CENPD-285-NP-RAI

Fuel Rod Design Methods For Boiling Water Reactors: Response to Request for Additional Information

CENPD-285-NP-RAI (NRC TAC No. M90188)

July 1995

Figure A2-1 RISO Rods PA29-4 and M2-2C Power Histories

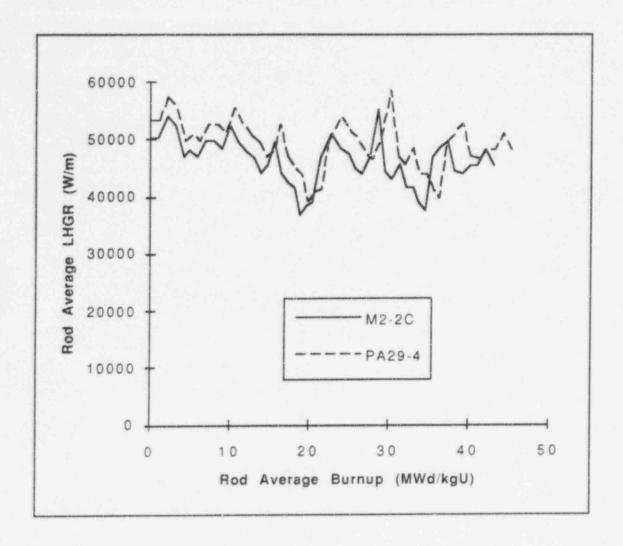
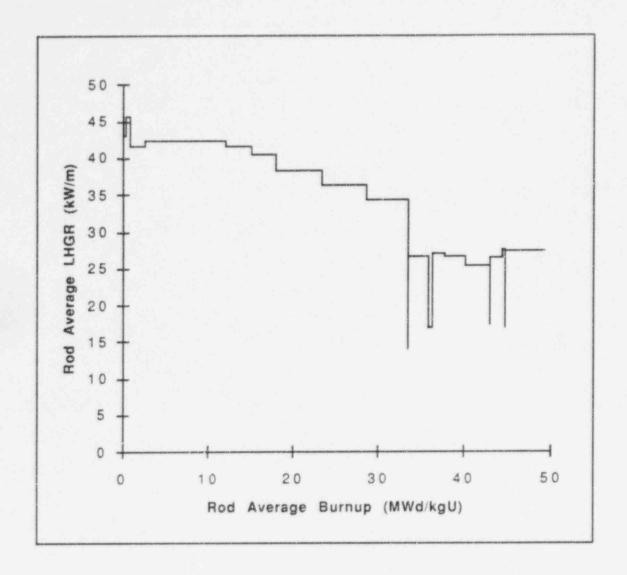
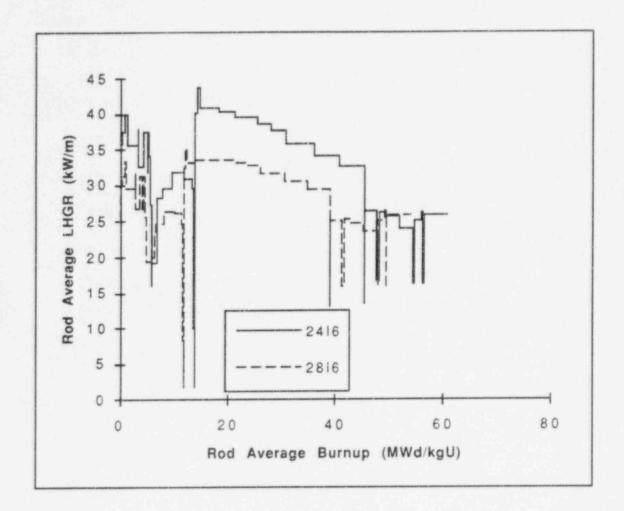
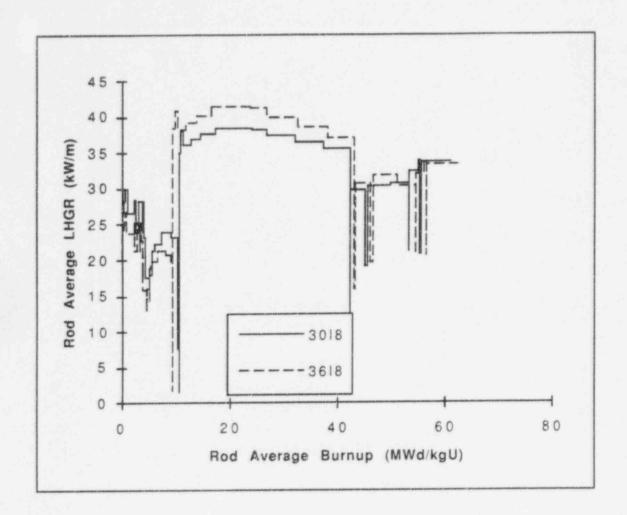
The code-to-data comparisons for fission gas release (Tables 3-8,3-9) are limited to cases where rod burnup does not exceed 45 GWd/MTU. We recommend comparisons be made to higher-burnup rods, particularly the BR-3 test rods described in Reference A-1, and the Riso test described in Reference A-2. If higher-burnup cases are not included, the code application for rod internal pressure will have to be limited to 45 GWd/MTU rod-average burnup.

In addition, comparisons between measured results in the BR-3 test rods and the Riso test rod have been made. These predictions were performed using the information provided in References A-1 and A-2 The results of these code comparisons are provided in Table A2-1.
